Date of Issuance: 2.19.2025  
Project: Hyrum City – Libbie Springs Park  
Subject: Contract Document revisions & bid Questions/Responses

Incorporate the following revisions to the Specifications, Drawings and other Contract Documents of the above named project. General Items are not referenced. Revisions to the Specifications are referenced by section, page number, and paragraph number. Revisions to the Drawings are referenced by drawing sheet number. This addendum forms part of the Construction Document.

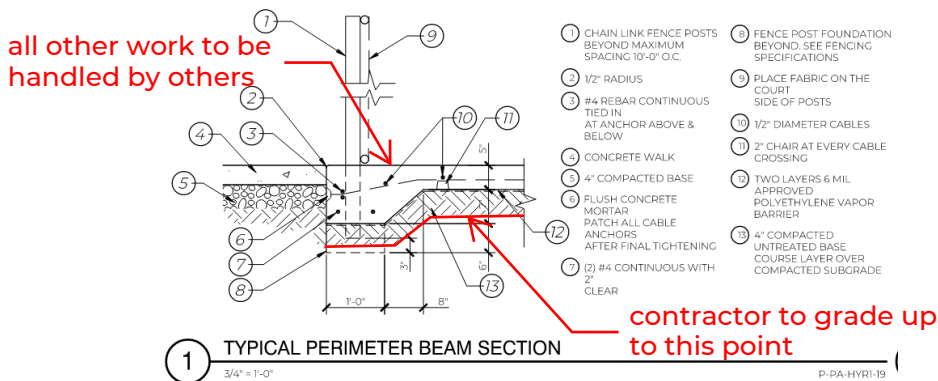
- Item2.6
  - Revise details 5, 11, and 12 as shown on attached C500

SHEET  
**C101**

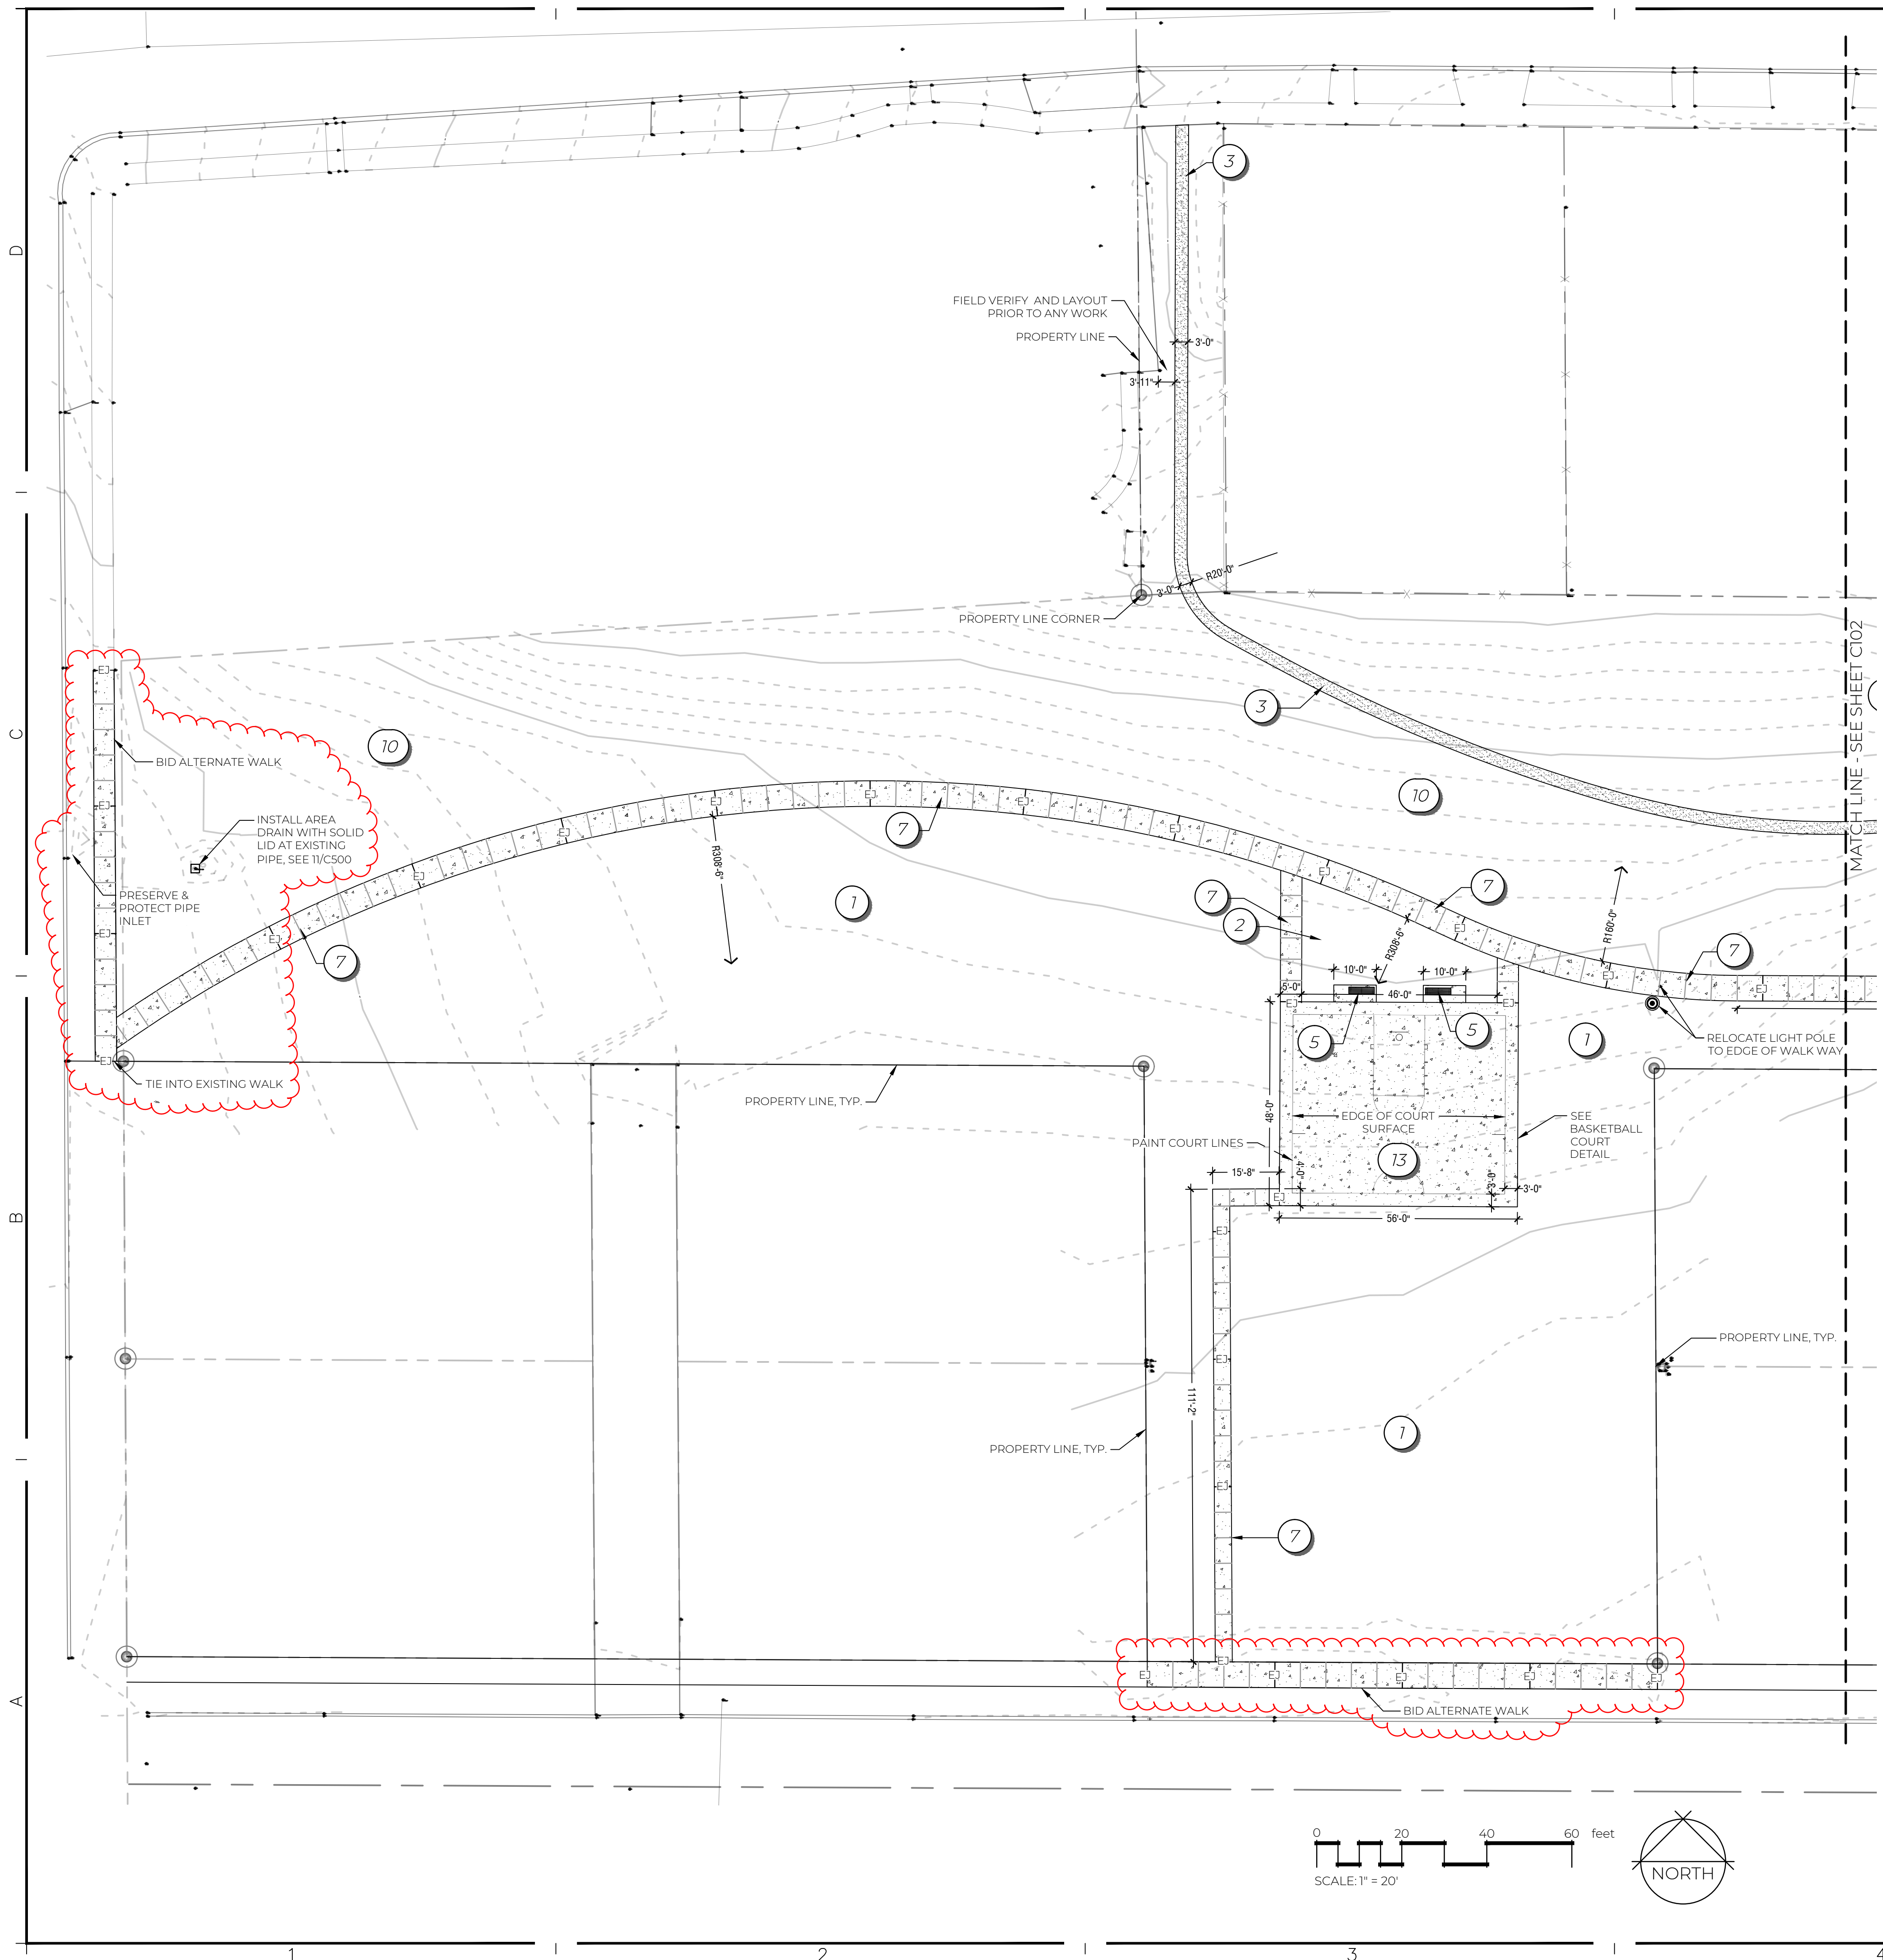
- Item2.1
  - Add bid alternate concrete perimeter walk in three different locations as shown on sheet C101 & C102. Install area drain as shown on sheet C101 at existing inlet pipe location. Assumed box height should be 3'-0" from flow line. Provide solid lid on area drain.
- Item2.2
  - Add concrete hatch to bench pads & bike rack pad C102.
- Item2.3
  - Remove boulders from trail at playground all 102 sheets.
- Item2.4
  - Add Sheets D001 Demolition Plan and C002 SWPPP, see attached. Contractor shall provide SWPPP plan and all permitting required by city and state.
- Item2.5
  - Sheets C202 cut existing grade hillside to provide fill along property line edge and at existing spring outlet. Anticipate 3-4 feet fill along spring flowline area after French drain has been installed.

4. Please clarify the perimeter sidewalks that should be included in the bid alternate.  
Response: See addendum #2 for info and attached sheets C101 & C102. Match grades of adjacent road with a 2% slope away. City will do work in parkstrip. Provide two 4" sleeves in each section of walk for owner to tie irrigation into parkstrip.

NO.	DATE	DESCRIPTION
AD2	2025.02.19	BID ALTERNATE & DRAINAGE

**5 THICKENED EDGE AT RAMP W/ HANDRAIL PLATE**  
1" = 1'-0"  
P-PA-HYRI-117

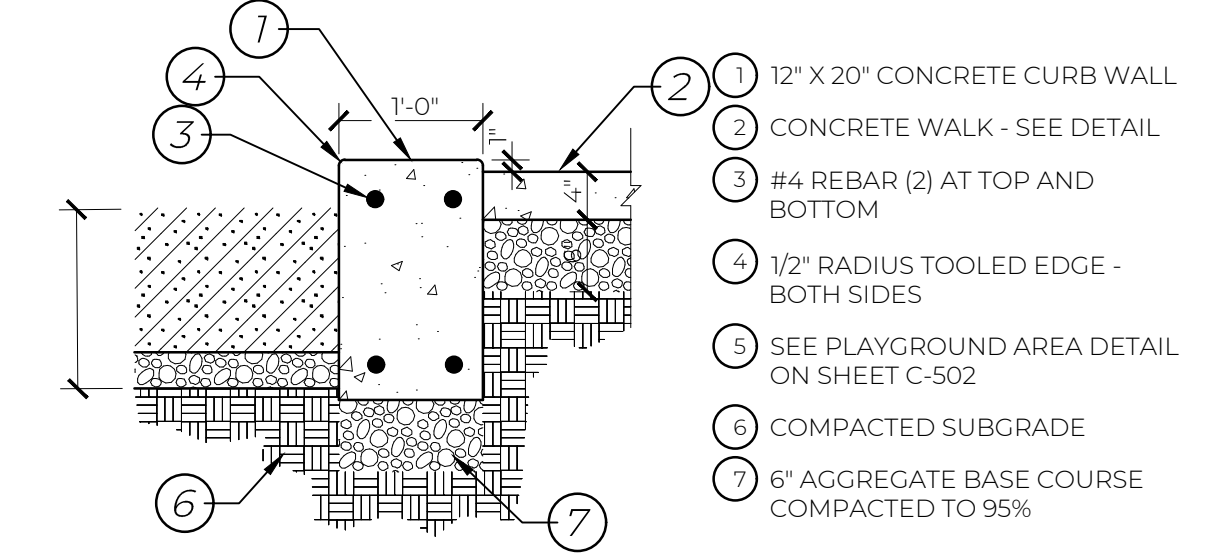
9. The ADA ramp with handrail is somewhat unclear. The plan shows what could be a curb on either side of the ramp (similar to 3/C501), but the detail shows steel at the lower part of the handrail. The detail does not show a rail at the midpoint of the handrail. The detail also shows a column footing for the handrail posts. Is there an option that we can use to allow for surface mounting the handrail or core drilling and grouting?

Response: Revise layout plan to remove the raised curb. See new detail 5/C500 and revised detail 12/C500.
10. Would it be acceptable to use #3 rebar @ 18"-24" O.C.E.W. in lieu of the WWF called out at the basketball court?
